Access Compliance Report

Public Rights-of-Way

Intersection ID: 24484	Main Street: SAINTFIELD_PL	Cross Street: SWINFORD_PL	Location: SW
ADA ID: BD80E10FBF78	Ramp Type: Perp	Initial Pass/Fail: Fail	Overall Compliance: No
		Severity Score: 8.75

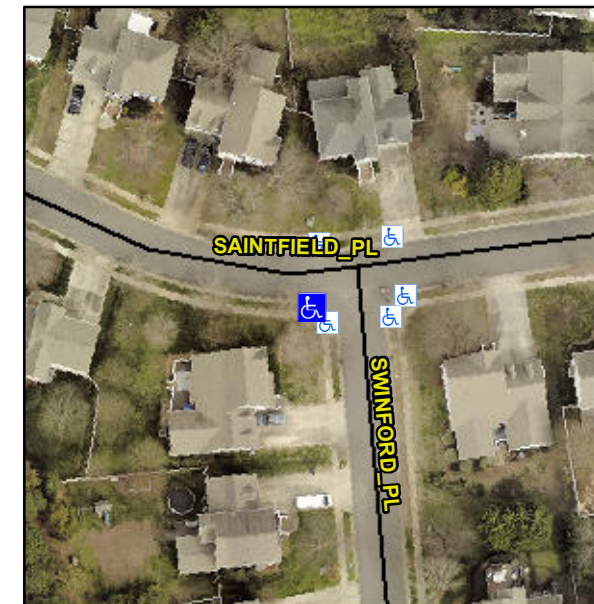
Not Found, R304.5.1

Compliance	Description	Data	Compliance	Description	Data
N/A	Ramp Length (in)	42.0	Yes	Ramp Slope (%)	6.9
No	Ramp Width (in)	41.0	Yes	Ramp XSlope (%)	0.1
N/A	Flare Type LT	N/A	N/A	Flare Type RT	N/A
N/A	Flare Slope LT (%)	N/A	N/A	Flare Slope RT (%)	N/A
N/A	Flare Traversable LT?	N/A	N/A	Flare Traversable RT?	N/A
N/A	Landing Length (in)	N/A	N/A	DWS Provided?	N/A
N/A	Landing Width (in)	N/A	N/A	DWS Contrast?	N/A
N/A	Landing Slope (%)	N/A	N/A	DWS Length (in)	N/A
N/A	Landing X Slope (%)	N/A	N/A	DWS Full Width?	N/A
N/A	Landing Curb? (Y/N)	N/A	N/A	DWS Offset (in)	N/A
N/A	Shared Landing?	N/A			
N/A	Gutter Ponding?	Yes	N/A	Gutter Slope (%)	N/A
N/A	Gutter Lip Ht (in)	N/A	N/A	Gutter X Slope (%)	N/A
N/A	Painted X Walk1?	No	N/A	Painted X Walk2?	N/A
	X Walk 1 Direction	To N		X Walk 2 Direction	N/A
N/A	X Walk 1 Width (in)	N/A	N/A	X Walk 2 Width (in)	N/A
	X Walk 1 Slope (%)	3.7		X Walk 2 Slope (%)	N/A
	X Walk 1 X Slope (%)	2.0		X Walk 2 X Slope (%)	N/A

Remove & Replace Entire Ramp.
